SAFETY RECALL NOTICE

Attention: Jerr-Dan Dealer
Subject: Replacement of Underlift Tilt Counterbalance Valve
Models Affected: Standard Duty Wrecker, MPL-NGS, MPL-NG and MPL40
Date: April 24, 2015
Reference Number: 15V-161

PROCEDURE: Underlift Tilt Circuit Counterbalance Valve Replacement Procedure
MODELS: Jerr-Dan Standard Duty Wrecker, Models MPL-NGS, MPL-NG and MPL40

Illustration #1

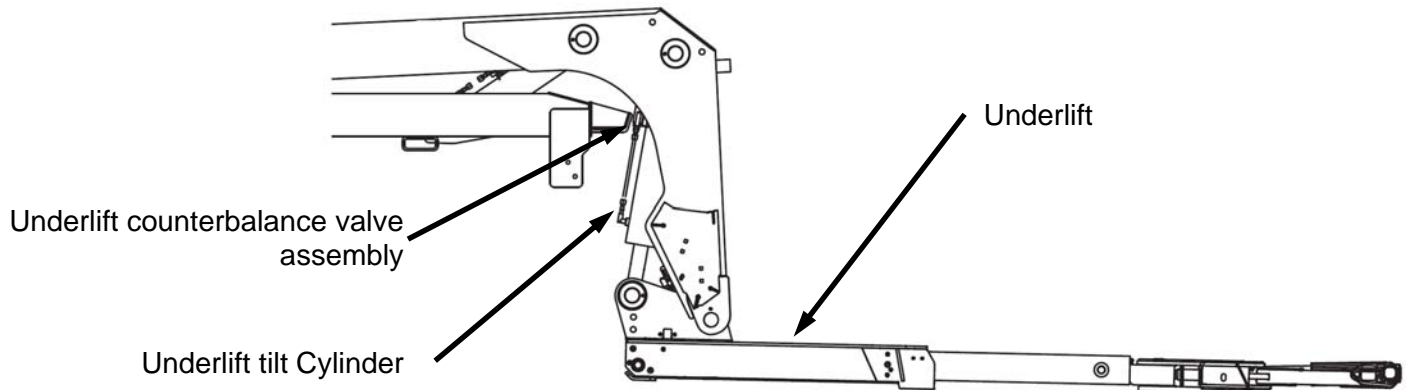
1. Position truck on a firm and level surface.
2. Properly chock the wheels of the truck.
3. Lower the underlift so that it sits on the ground surface.
4. Tag the truck out of service to prevent further use during the course of this procedure.
5. Ensure that the engine has been shut off and the hydraulic fluid has cooled.
6. Thoroughly clean the area around the hydraulic valve assembly area of the underlift tilt cylinder.
7. Remove necessary items and components in order to gain access to the underlift tilt cylinder. Reference Illustration #1.
